**DOCUMENT 00 90 00  
ADDENDUM**

**ADDENDUM NO. [4]                      Date: November 21, 2018**

**RE:                      GLENWOOD COMMUNITY SCHOOL DISTRICT  
ATHLETIC COMPLEX IMPROVEMENTS BID PACKAGE 2 REBID  
400 SIVERS ROAD  
GLENWOOD, IOWA 51534  
HSR PROJECT NO. 18005**

**FROM:                  HSR Associates, Inc  
100 Milwaukee Street  
La Crosse, WI 54603  
(608) 784-1830**

**P101R**

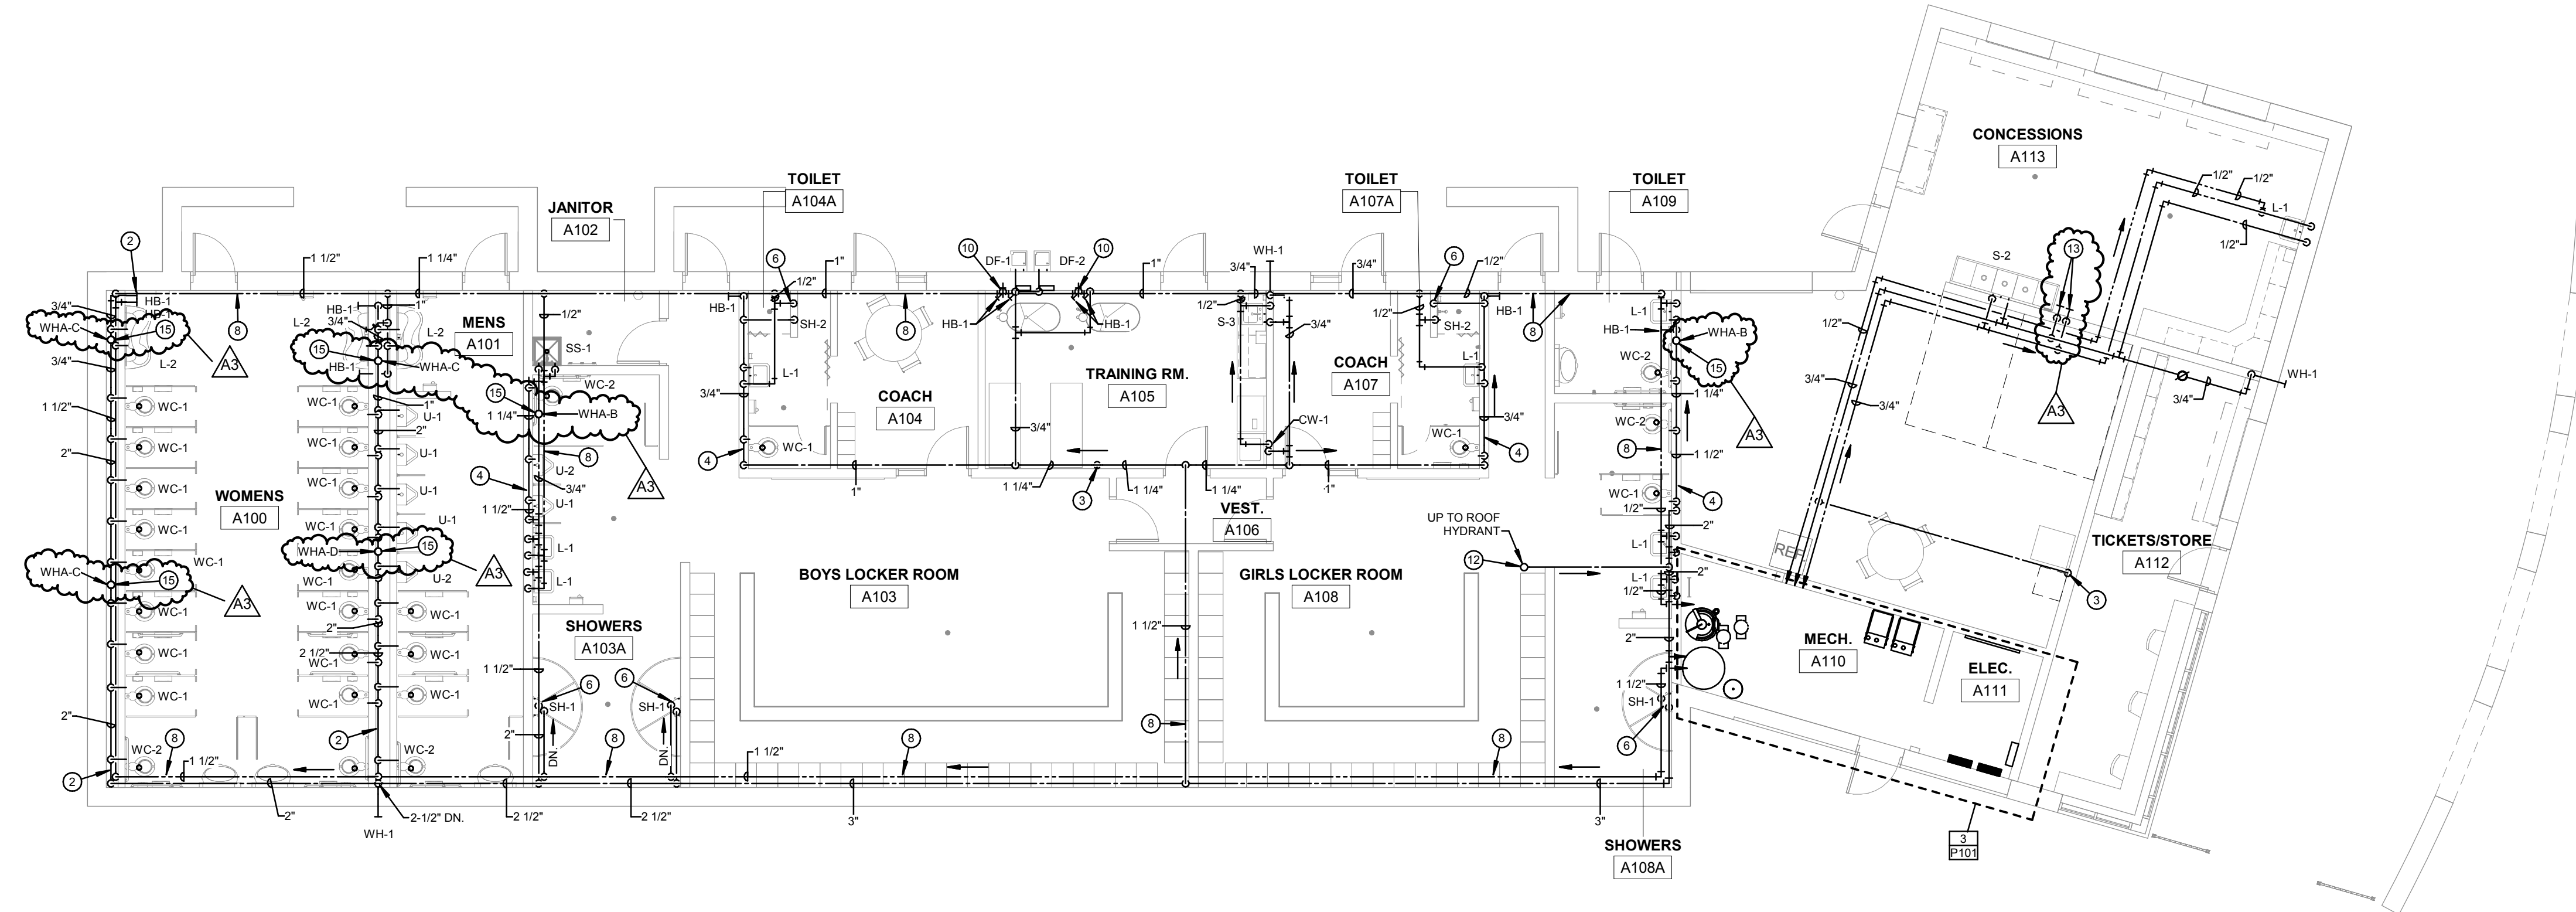
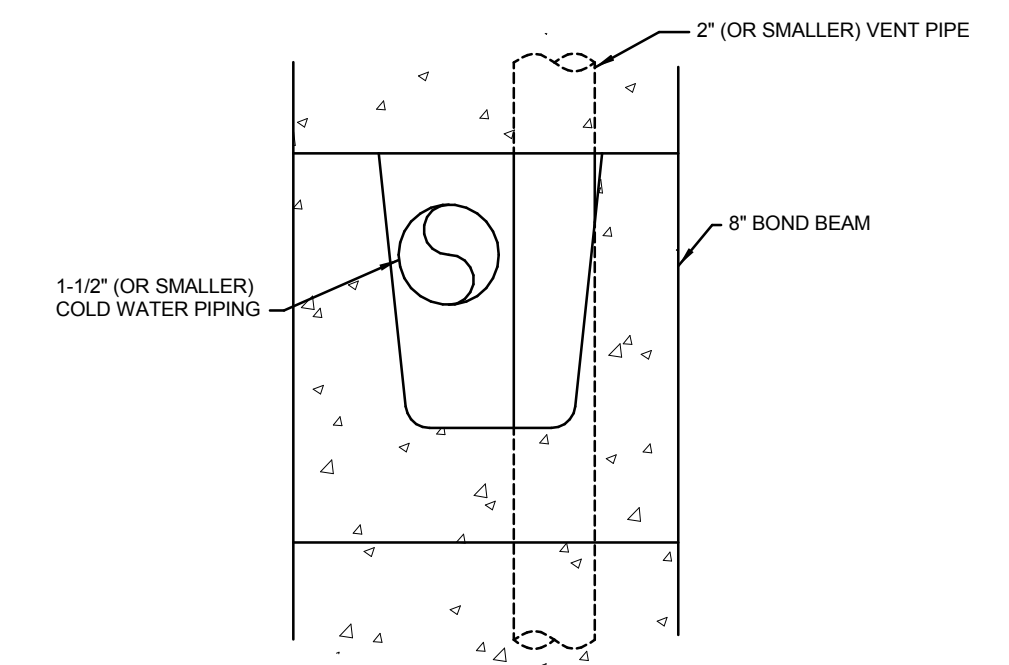
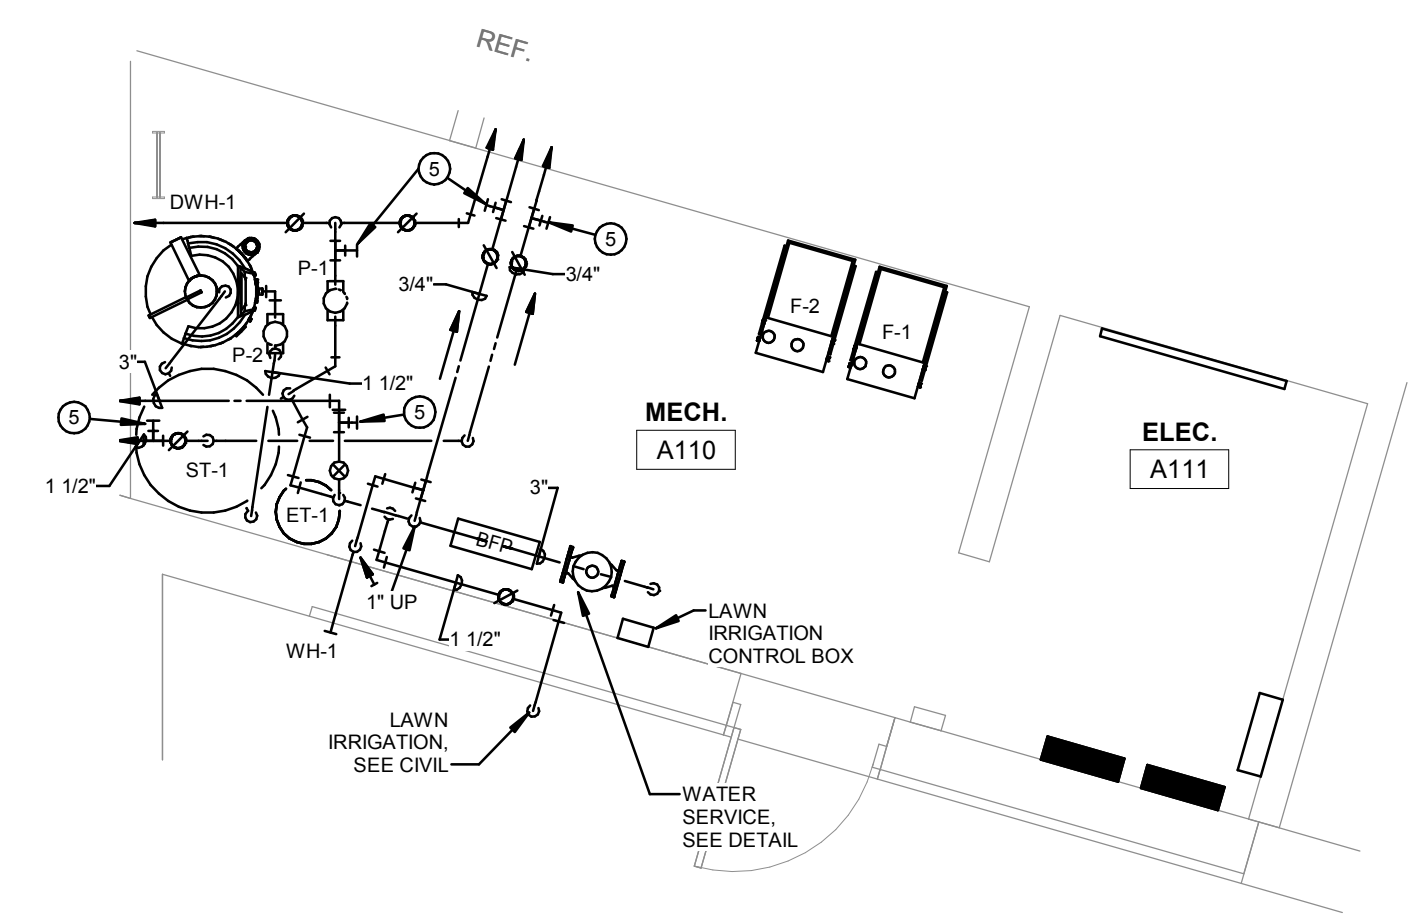
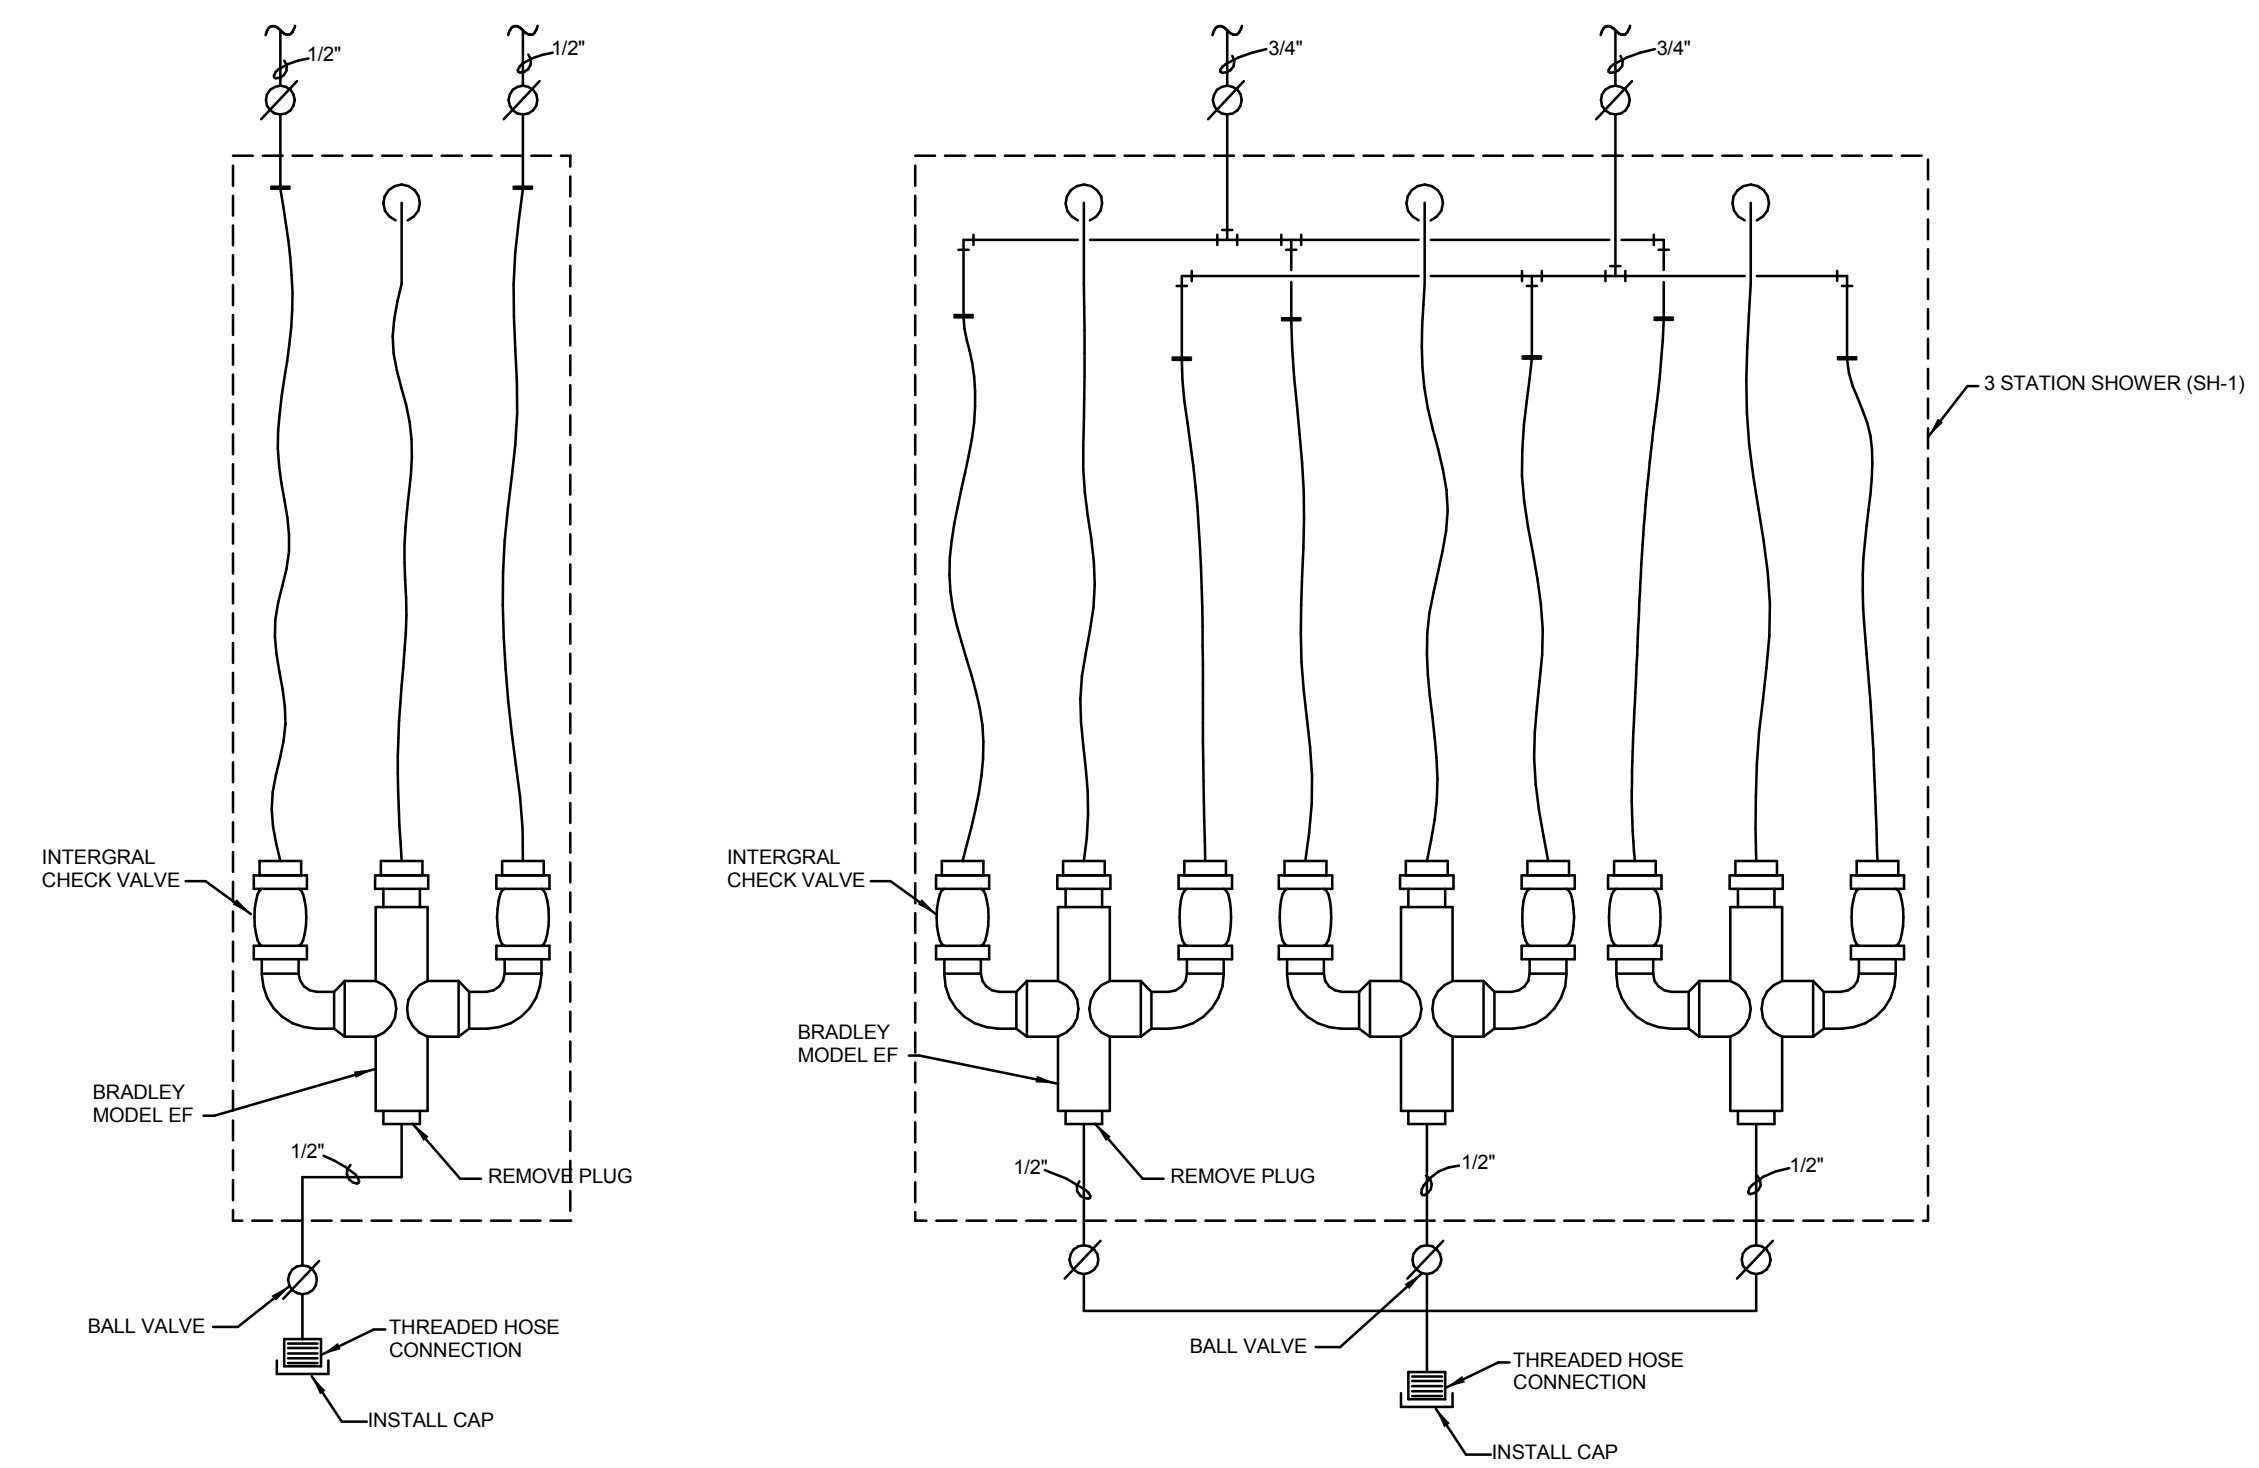
3. Sheet P101R GATEWAY BUILDING PLUMBING PLAN 30 x 42 attached hereto.
  - a. Revisions clouded on Drawing
  - b. In Concessions A113; cap 3/4" gas pipe at 10'-0" above finished floor for future range, extend 3/4" domestic hot and cold water down wall to electric kettle. Terminate at 18" above finished floor with ball valve and threaded hose connection. Added floor sink adjacent to electric kettle.

- c. Extend drain line from roof hydrant over to floor drain in MECH. A110.
  - d. Added water hammer arrestors in domestic cold water pipe where shown. Refer to schedule on P103.

- e. Added sheet notes 11, 12, 13, 14, and 15.
